MD120UI Release note

Product : MD120UI

15. Support more options to overwrite the setting when Importing Setting Data

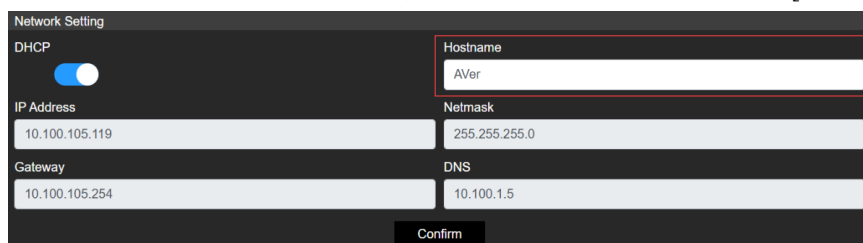
WebUI >> System >> Setting >> Import Setting Data

Check the [User Account] , [Network Setting] if you want to overwrite

16. Support Hostname on MSFT DNS server for better device management

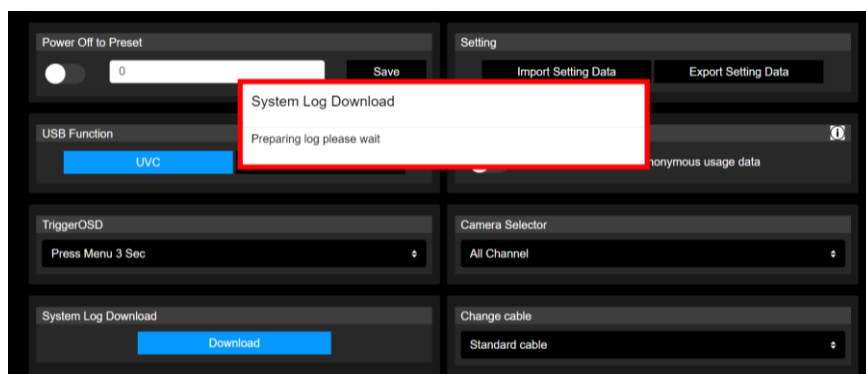
web UI >>> Network >>> Hostname, set the camera hostname and click [Confirm]
